Work Order ID 129299

Item Name: Crosstube Turning Detail

DRAWING NO. D407-667-145	TITLE CROSSTUBE ASS'Y (407 HIGH FWD)	REV. C	DART AEROSPACE LTD ENGINEERING ORDER		D.E.O. NO. D407-667-145-C-1	SHEET NO. SHEET 1 OF 1	SCALE NTS
DRAWN AP	CHECKED ASS	MFG. APPR. AB	APPROVED WD		DE APPR. H		
DATE 11.07.15	DATE 11.07.22	DATE 11.07.22	DATE 11/07/22		DATE 11.07.21

DRAWING NO. D407-667-145	TITLE CROSSTUBE ASS'Y (407 HIGH FWD)	REV. C	DART AEROSPACE LTD ENGINEERING ORDER	D.E.O. NO. D407-667-145-C-2	SHEET NO. SHEET 1 OF 1	SCALE NTS
DRAWN AJS	CHECKED J	MFG. APPR. E	APPROVED AP	DE APPR. H	DATE 12.08.02	DATE 12.08.02

DETAIL P
BONDING STRAP INSTALLATION 2 PL

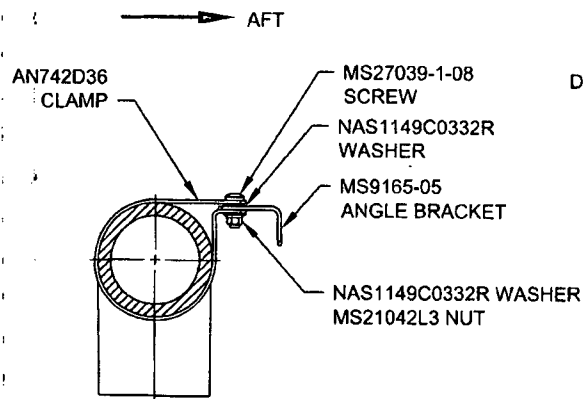
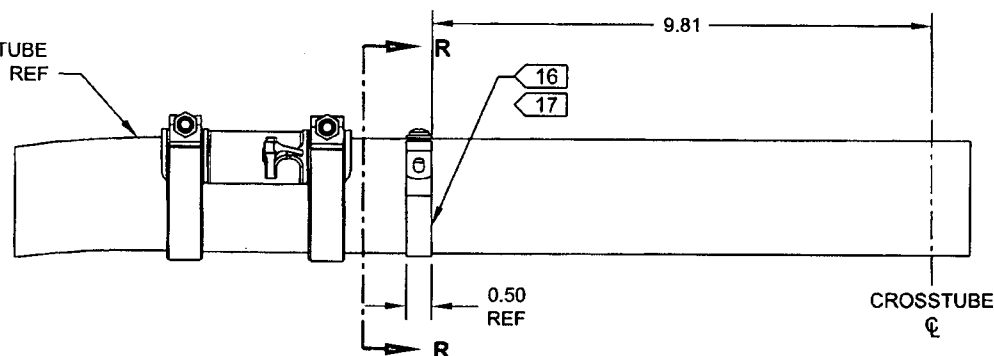
ADD ELECTRICAL GROUNDING STRAP

ITEM	QTY -145	PART NUMBER	DESCRIPTION
1	X	D407-667-145	CROSSTUBE ASSEMBLY (407 HIGH FWD)
10	2	AN742D36	CLAMP
11	2	MS9165-05	ANGLE BRACKET
12	2	MS21042L3	NUT (OR MS21042-3)
13	2	MS27039-1-08	SCREW
14	4	NAS1149C0332R	WASHER (OR AN960C10L)

- 16) MASK AREA UNDER CLAMP PRIOR TO PAINTING
- 17) SEAL EDGES WHERE AN742D36 CLAMP MEETS WITH THE CROSSTUBE USING SIKAFLEX-241/-291 OR MIL-S-8802 CLASS B2 OR PROSEAL 890 SEALANT
- 18) PERFORM RESISTANCE CHECK TO ENSURE MAX RESISTANCE IS 10 MILLIOHMS
